Architectural Review Board Meeting Agenda

1. Project: 23-2228-ARB/CDP
Address: 5459 Shemara Street
Applicant: Gabriel Zamora, Architect, for Emma Davis
Planner: Marysol Smith

2. Project: Klentner Mixed-Use Development, Project 23-2221-DP/CDP
Address: 4745 Carpinteria Avenue
Applicant: Michael Stroh, DMHA Architects, for Justin Klentner
Planner: Nick Bobroff / Brian Banks

Project: 23-2228-ARB/CDP **Planner:** Marysol Smith
Address: 5459 Shemara Street
APN: 001-272-009
Zoning: Single-Family Residential District (8-R-1)
Applicant: Gabriel Zamora, Architect for Emma Davis

PROPOSED SITE PLAN

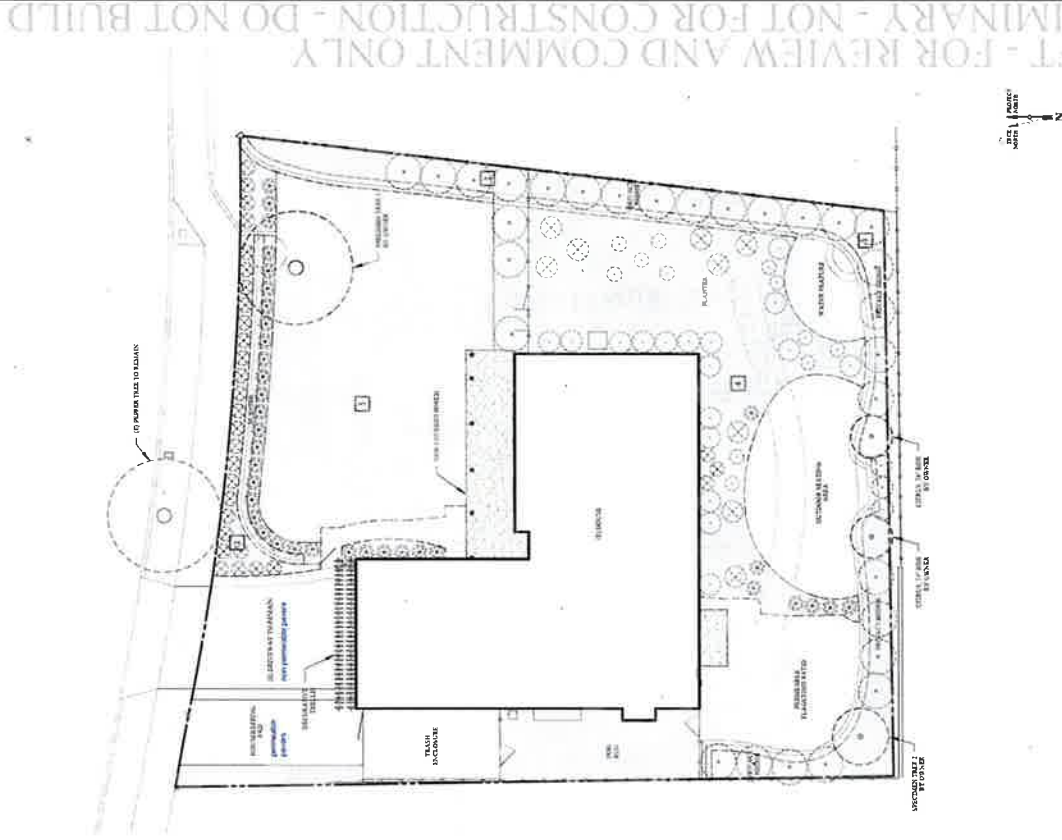
The project proposes a 24-inch high rock planter wall with plantings (Mexican Sage) above for a total height of approximately 50+ inches. The front yard would be infilled to be level with the back of the new rock wall planter. CMC 14.50.050 states that fences, walls and landscape plantings in excess of 3 feet may be permitted, subject to the approval of a Fence Permit, if the following findings are made:

Given these particular site conditions, Staff finds a hedge/wall taller than three feet could be found to be consistent with the Municipal Code's criteria addressing neighborhood compatibility. **The Board should comment on whether the grounds for approval of a Fence Permit would be met. If the Board finds the proposal appropriate, the Board should provide specific recommendations to the Director regarding the selected species and maximum height of the plantings.**

The landscaping plan proposes a palate of low- and medium-water use shrubs and a privacy hedge long the eastern and rear property lines. A lawn is proposed in the front yard between the rock planter wall and front porch, and a permeable stepping stone path will connect the driveway to the porch. The proposed lavender bushes on the eastern side of the house could help screen the new A/C unit. A permeable flagstone patio is proposed in the rear western corner of the lot, and a crushed gravel seating area centered at the rear. A water feature is proposed in the rear eastern corner. **The Board's feedback on proposed plants and hardscaping in the front yard is appreciated.**
